## **AMENDMENTS TO THE DRAWINGS**

## **REMARKS**

AMENDMENT DATED DECEMBER 17, 2004

**FIG. 5**

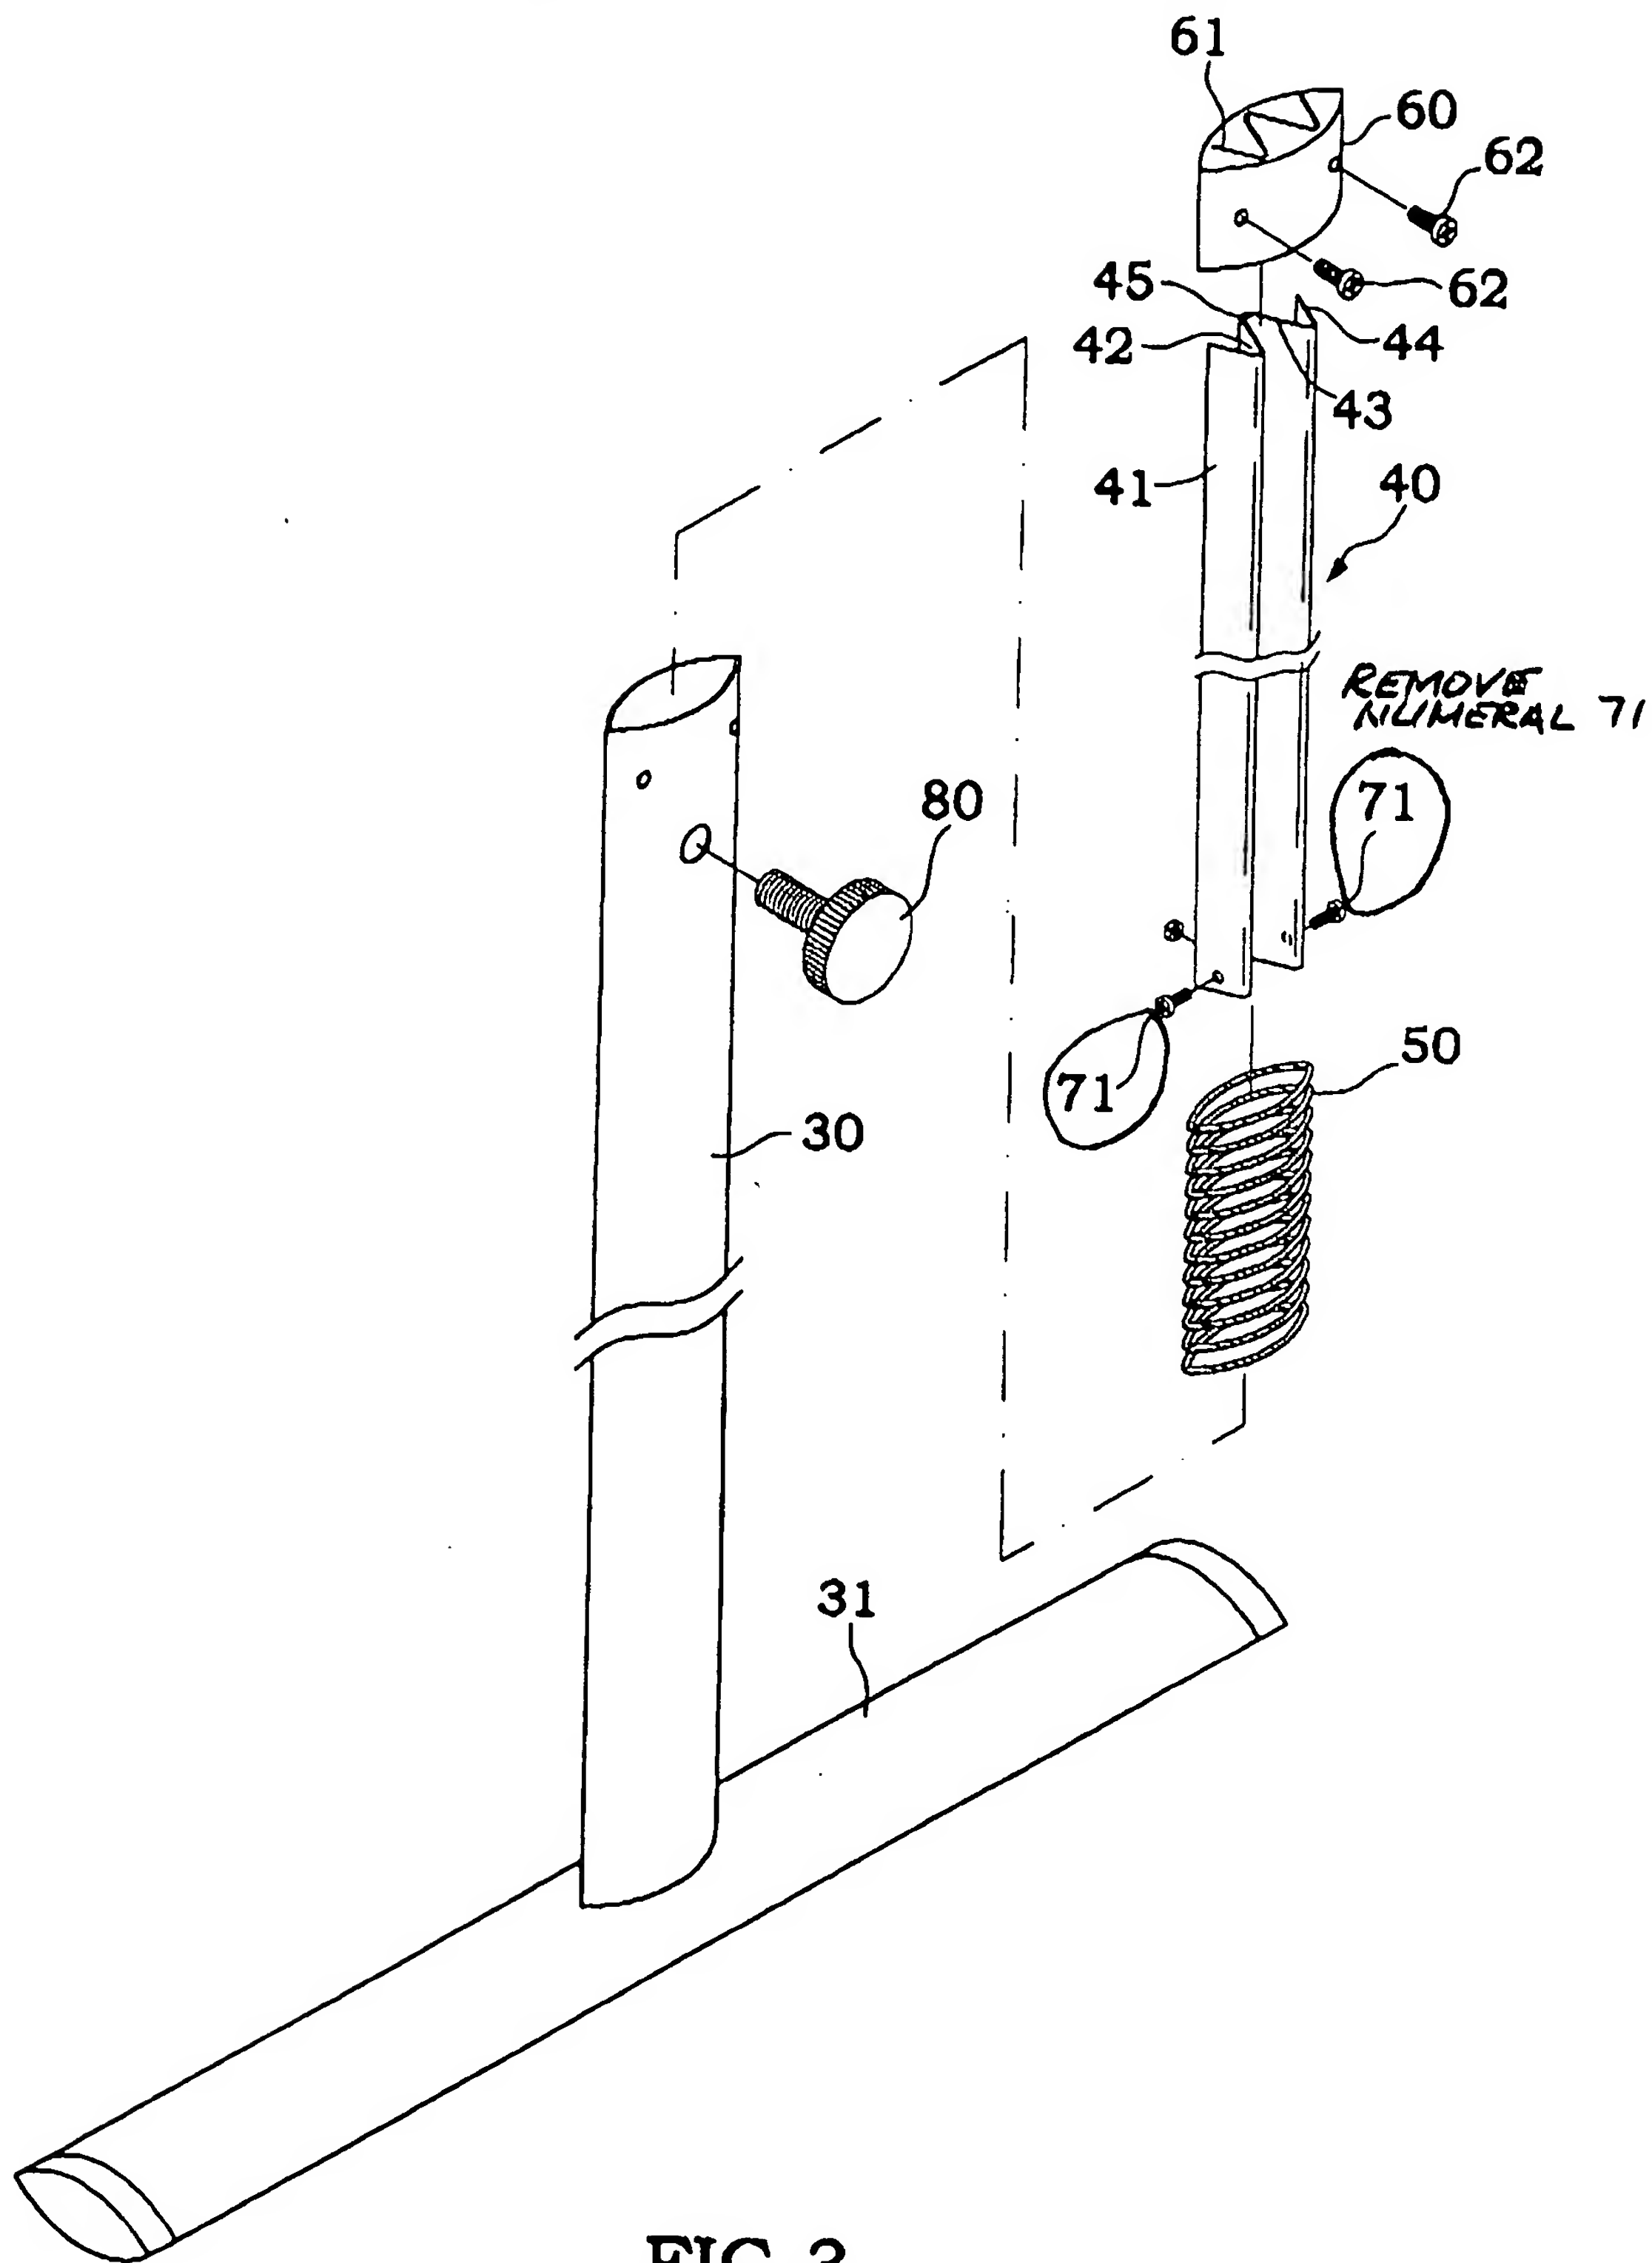
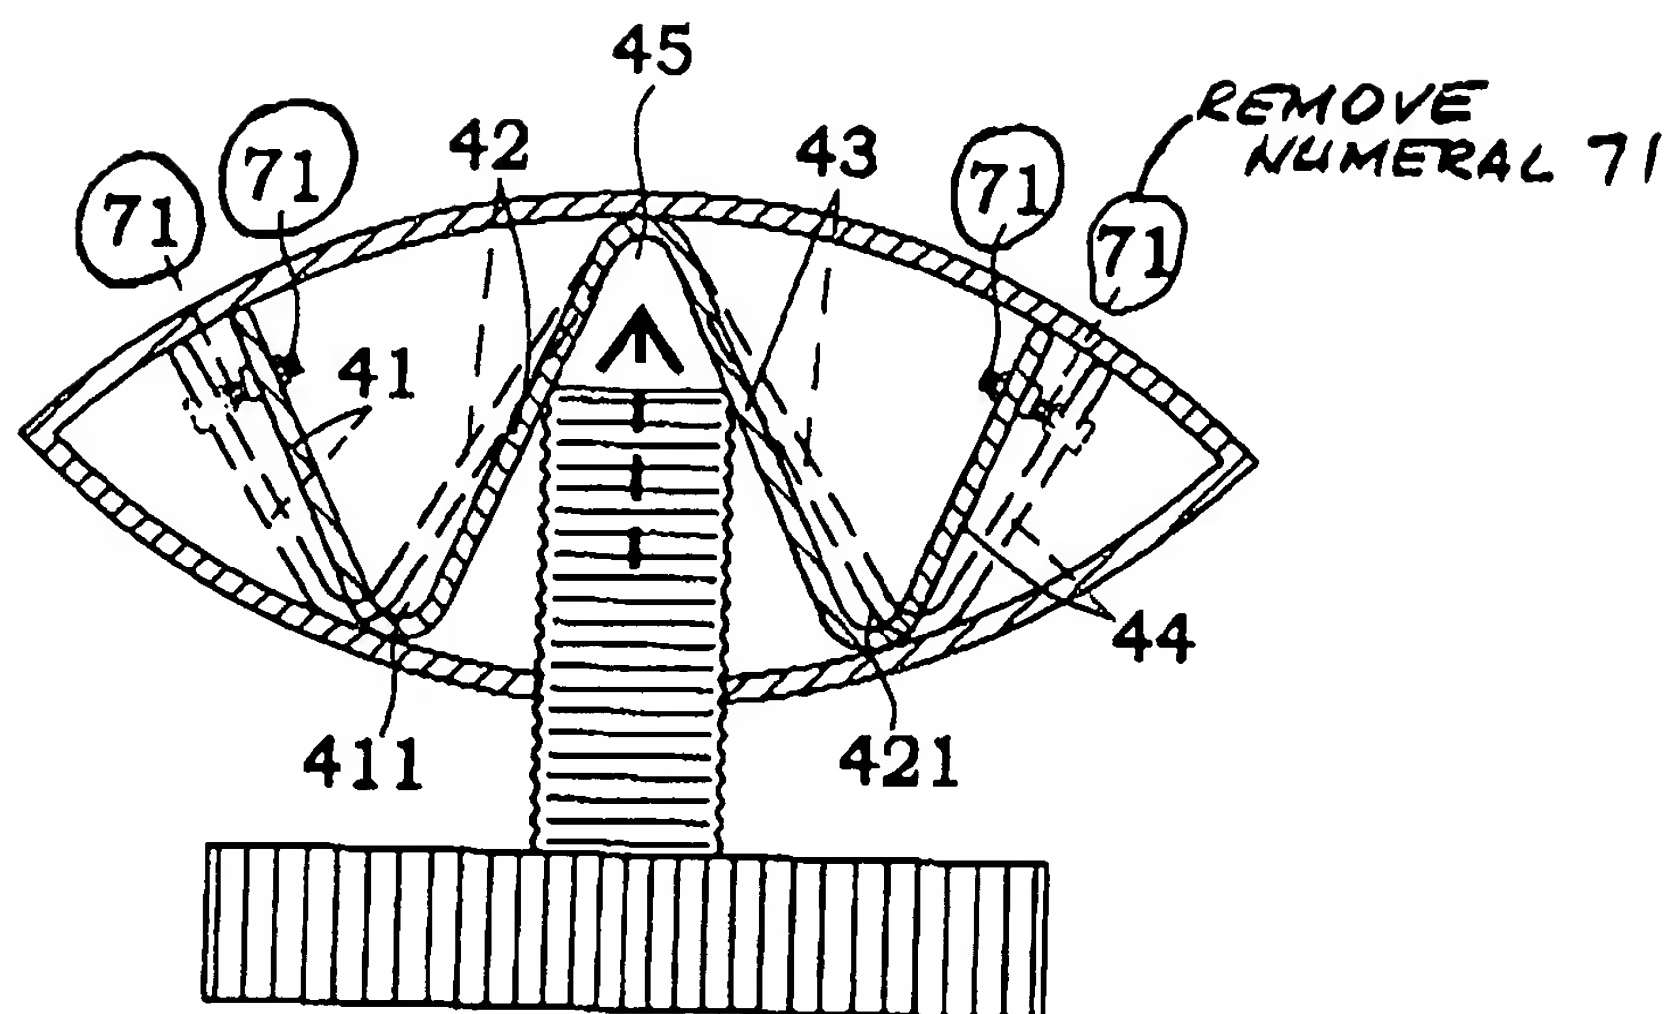
An attachment to this paper contains replacement sheets and annotated sheets for Figs. 3 and 5. The annotated sheets indicate the removal of reference numeral 71 in accordance with the Examiner's comments.

An attachment provides revised drawings as required by the Examiner. In the revised drawing reference numeral 71 has been deleted in figs. 3 and 5. The Specification has been amended to remove an incorrect use of reference numeral 10. Thereby eliminating a need to add reference numeral 10 to the drawings.
